## Accessibility Survey

### City of Downey Fostoria Street - Pangborn Avenue To Newville Avenue

Date of Inspection  
5/4/2017

**Disability Access Consultants**

**North Side @ 33.934935173666, -118.115840256214**

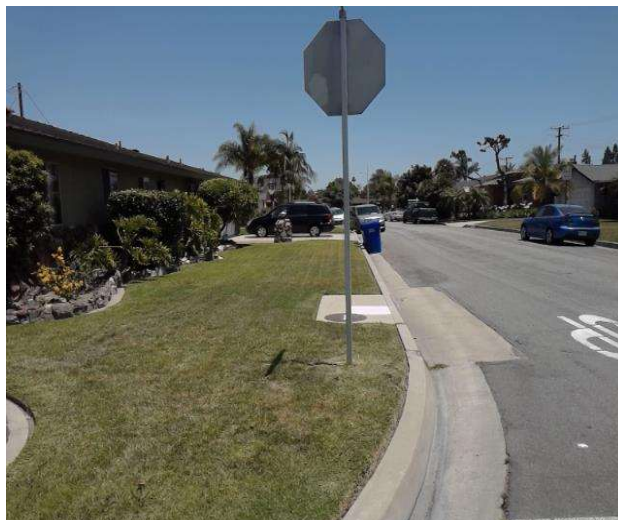
No sidewalk exists at the location.

**On-Site Finding** Not Found

No action necessary until a sidewalk is provided.
